NARRABRI TO TURRAWAN LINE UPGRADE

SUBMISSIONS REPORT MAY 2022

Figure 3 Indicative location of alternative access options into Fraser Street

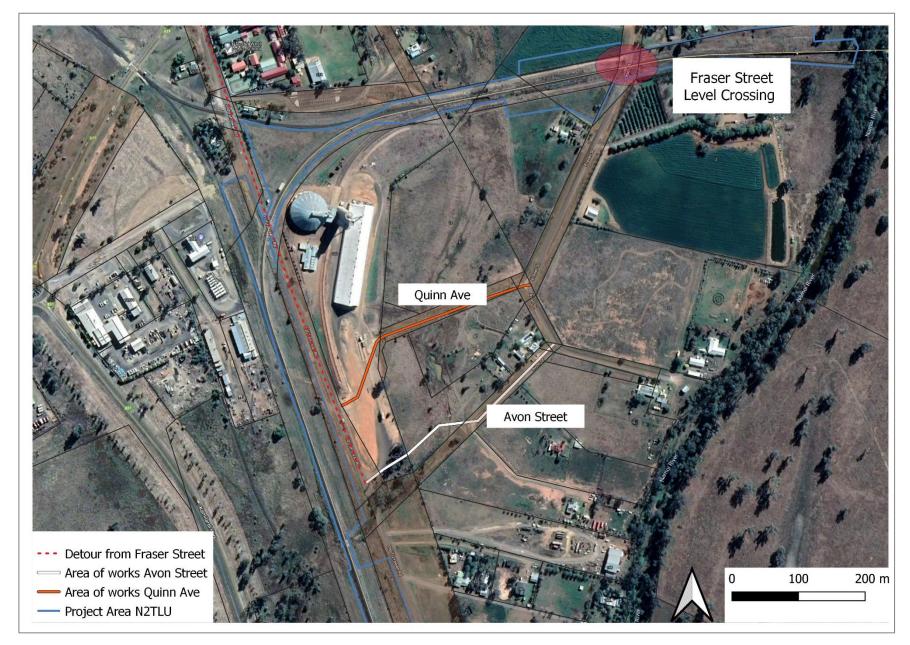
The REF notes that alternate access may be required to maintain residential access during level crossing works, however, it was generally intended that vehicles would be diverted adjacent to the work site at the Fraser Street level crossing. On further review, it is considered preferable to restrict all vehicle access though the Fraser Street level crossing during the level crossing upgrade works. The restriction will avoid managing vehicular access in close proximity to an active work site and will provide a safe work area for construction personnel during the works. With access restricted along Fraser Street alternate residential access may potentially be provided via a detour along the Newell Highway, Old Turrawan Road and then either through:

- (a) Avon Street; or
- (b) Quinn Avenue.

Both alternate access options require road works (i.e. importation of geofabric, appropriate fill material, formation, compaction and temporary drainage) to facilitate an all-weather temporary vehicular access along existing unformed Council Road reserves and across portions of private land. At this stage it is anticipated that on the completion of the level crossing works, the temporary access road will be removed and the land returned to its original condition, however, the access road may be retained if required and/or in agreement with Council and/or the land owner.
